UNITED STATES PATENT AND TRADEMARK OFFICE

APPLICATION NO.	FILING DATE	FIRST NAMED INVENTOR	ATTORNEY DOCKET NO.	CONFIRMATION NO.
10/579,704	05/11/2007	Frank Spratt	DEP5221USPCT	5123

Office Action Summary	Application No. 10/579,704	Applicant(s) SPRATT, FRANK	
	Examiner STEVEN J. COTRONEO	Art Unit 3733

DETAILED ACTION

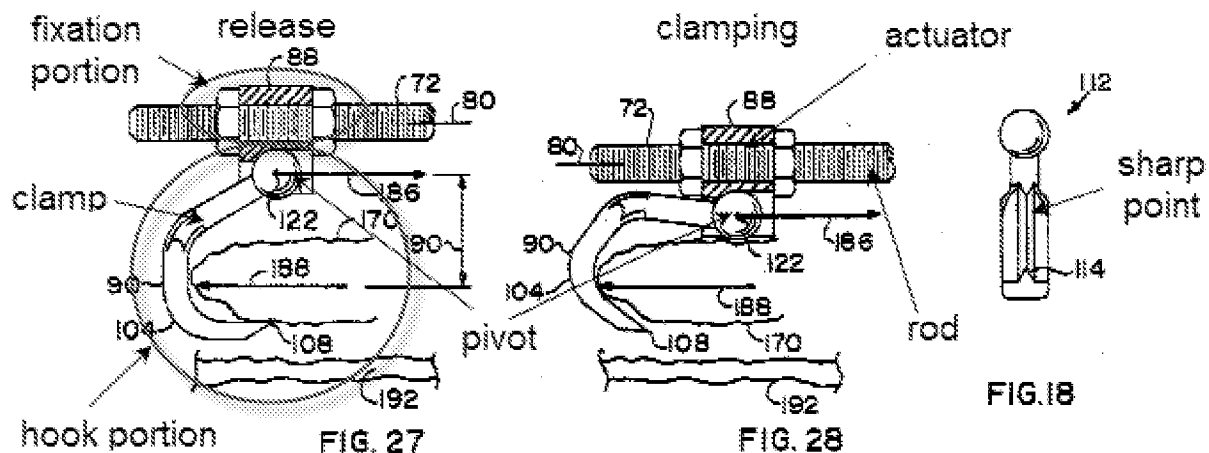
Miskew discloses a hook for fixing a spinal support rod to a vertebra by engaging the vertebra (see figs 18, 27 and 28 below). The hook portion (see fig 27 below) has a recess in which vertebral tissue is received and a fixation portion (see fig 27 below)

which includes a channel in which a spinal support rod is received. The hook includes a clamp having a sharp tip (fig 18, 114) that penetrates the surface of the vertebra. The clamp is pivotally fixed to the hook between a clamping position (fig 28) in which it engages the surface of the vertebra to inhibit removal of the vertebra from within the recess, and a release position (fig 27) in which vertebral tissue can be inserted into and removed from the recess. The distance between the clamping position and the release position is less than 5 mm (the distance between a clamping position and the release position can be very small because the difference from be clamped a not clamped is infinitesimal i.e. very small movement is required to finally lock the system). In the clamping position the recess is smaller (fig 28 compared to fig 27). An actuator that is a grub screw (located on the surface of the rod) causes clamping (col. 9, ll. 39-51). The clamp abuts a stop when clamped (see fig 28 below). The rod directly causes the clamp to penetrate bone. The clamp is inclined (fig 27).
